501 CAROLE LN

INDIVIDUAL WATER AND WASTEWATER SYSTEMS PROGRAM
APPLICATION FOR SERVICES

PROPOSED PLOT PLAN

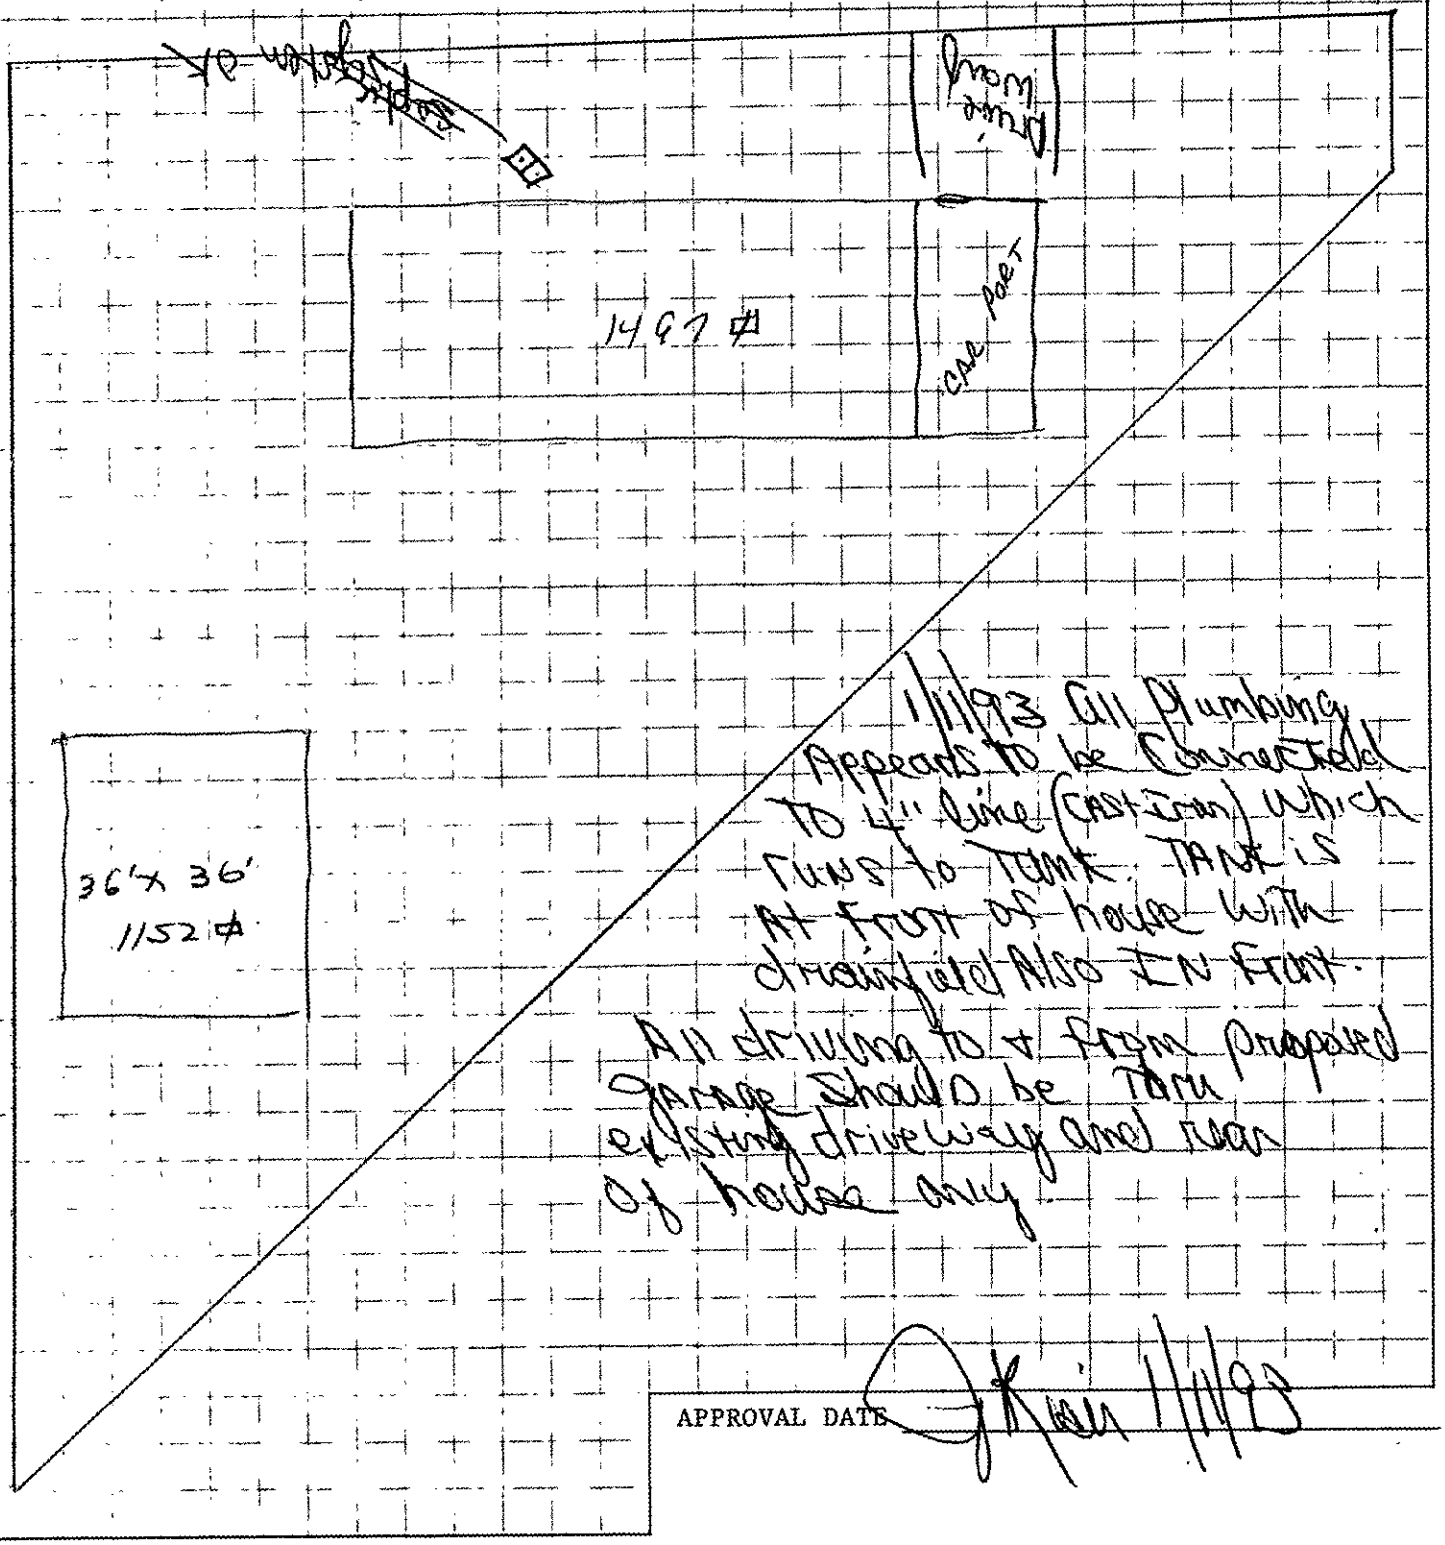
1/11/93 All Plumbing Appears to be Connected to 4" line (cast iron) which runs to Tank. Tank is in front of house with drainfield also in front. All driving to & from proposed garage should be Tarn existing driveway and rear of house only.
